Project	IEEE 802.16 Broadband Wireless Access Working Group < http://ieee802.org/16 >	
Title	Coexistence Recommended Practice – draft amendment version 1	
Date Submitted	2002-07-11	
Source(s)	Philip Whitehead Radiant Networks PLC The Mansion, Chesterford park Little Chesterford, Essex, CB10 1XL UK	Voice: 01799 533600 Fax: 01799 533601 mailto:pw@radiantnetworks.co.uk
Re:	Amendments to Recommended Practice for Coexistence of Fixed BWA Systems IEEE802.16.2	
Abstract	This is the first complete draft amendment to the Recommended Practice for Coexistence of Fixed Broadband Wireless Access Systems	
Purpose	First complete draft for consideration of start of WG letter ballot at session # 20	
Notice	This document has been prepared to assist IEEE 802.16. It is offered as a basis for discussion and is not binding on the contributing individual(s) or organization(s). The material in this document is subject to change in form and content after further study. The contributor(s) reserve(s) the right to add, amend or withdraw material contained herein.

IEEE Draft Recommended Practice for Local and Metropolitan area networks

Coexistence of Fixed Broadband Wireless Access Systems

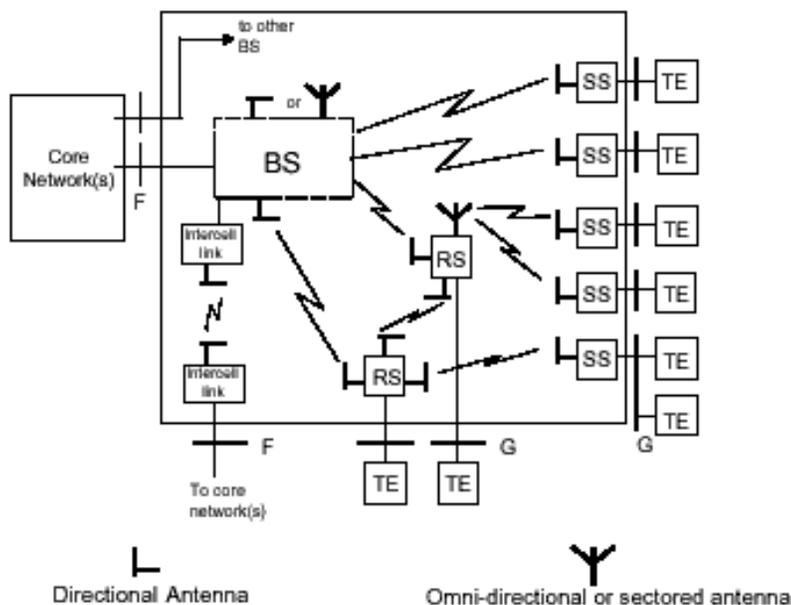
- Delete source statement [SOURCE: ETSI 301 390 v1.1.1 (2000 – 12)] and move to after figs 8 and 9
- Delete figure 1 caption [**Figure 1 – Interference Sources to a fixed BWA BS**] and replace with “Figure 1.1; Reference Diagram for Fixed BWA Systems”

Figure 6 -Unwanted emissions

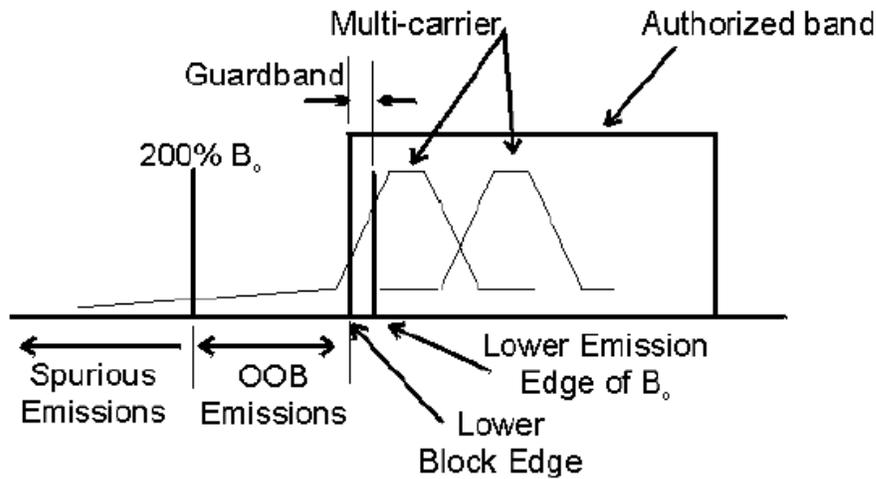
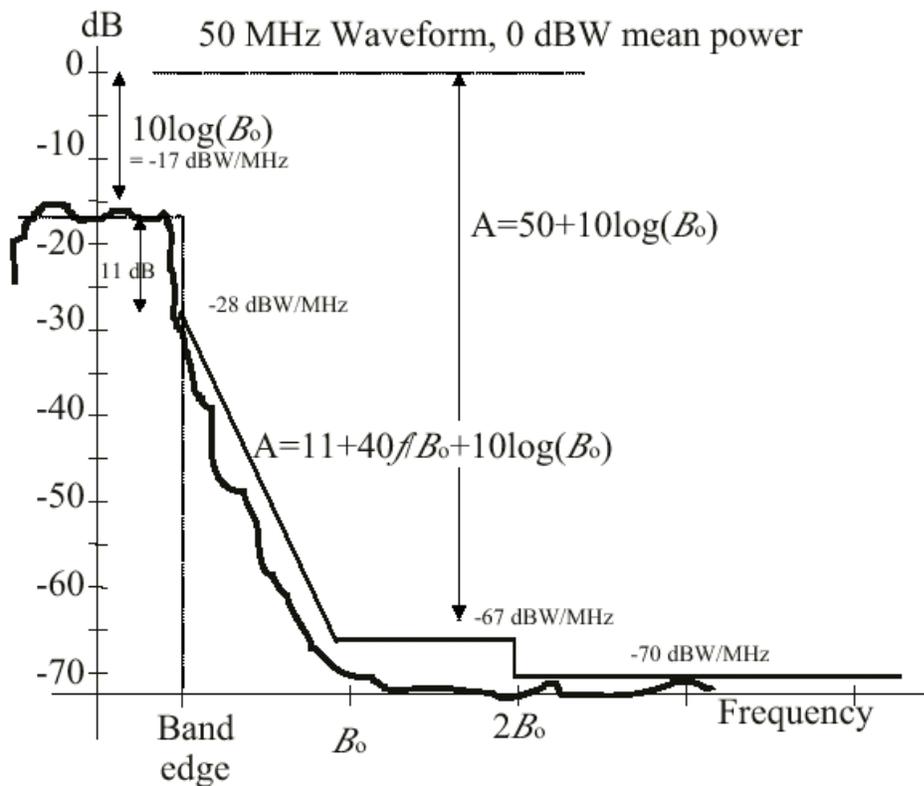
- Delete old text in 6.1.3
- Replace with new text below
- Delete figures 6 and 7

“Unwanted emissions produced by an operator’s equipment and occurring totally within an operator’s authorized band are relevant only for that operator and are not covered in this Recommended Practice. Unwanted emissions from an operator into adjacent bands should be constrained to avoid giving unacceptable interference to users of adjacent spectrum. Recommended emission limits are given below. As indicated in Figure 6, single-carrier or multicarrier transmissions whose occupied bandwidth is totally within the authorized band will nevertheless emit some power into adjacent bands. These unwanted emissions include out-of-band (OOB) emissions (within 200% of the emission occupied bandwidth (Bo) of the authorized band edge) and spurious emissions (beyond this 200% point).

The spectral density of unwanted emissions at the input to the antenna port should be attenuated by at least A (dB) below the total mean output power P mean as follows:

Figure 7 provides an example of how the unwanted emission mask would be applied to a hypothetical 50 MHz single carrier, located at the edge of the authorized band with a mean power of 0 dBW.

- The in-band spectral density will be $0 - \log_{10}(50) = -17$ dBW/MHz.
- The first section of the equation “ $A = 11 + 40f_{\text{offset}}/B_o + 10\log_{10}(B_o)$ ” starts 11 dB below this in-band spectral density and falls linearly with offset frequency from the band edge
 - In this example, the attenuation A reaches a value of -67 dB shortly before a 50 MHz offset and at that point the attenuation floor of if $A = 50 + 10\log_{10}(B_o)$ starts and continues at this value until a “ $2B_o$ ” offset. In this example, the second adjacent channel attenuation is thus -50 dBc.
- Beyond the $2B_o$ frequency offset, the spurious emission absolute limit of -70 dBW/MHz starts and continues out indefinitely.

Figure 1.8 – Systems for channel separation $1 < CS^* \leq 10$ MHz

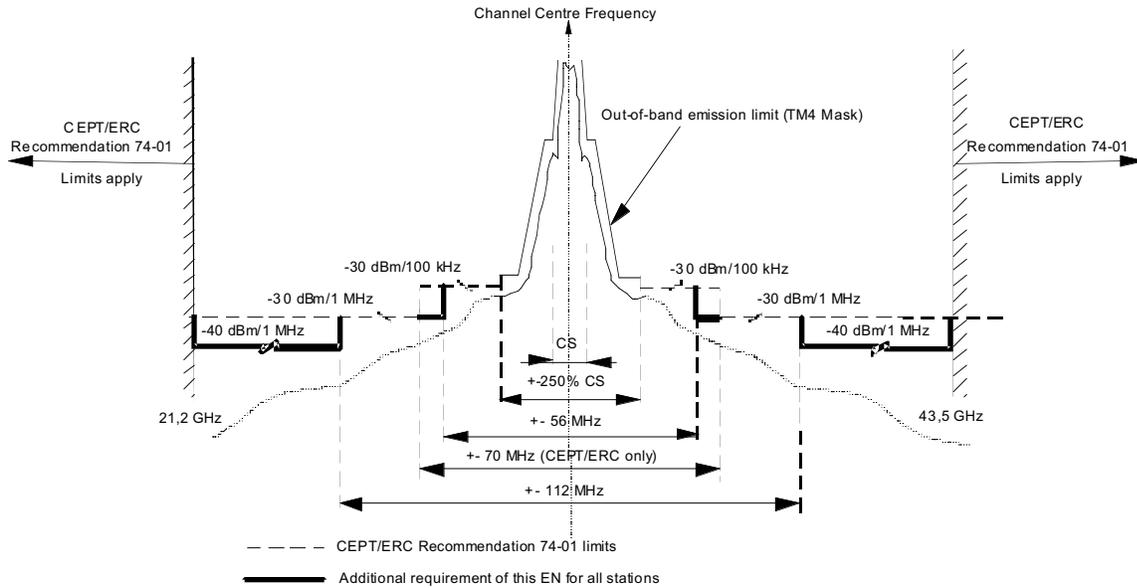
Editorial Instructions:

Add ETSI acknowledgement “SOURCE: ETSI EN 301 390 v1.1.1 (2000-12), Fixed Radio Systems; Point- to- Point and Point- to- Multipoint Systems; Spurious Emissions and Receiver Immunity at Equipment / Antenna Port of Digital Fixed radio Systems.”
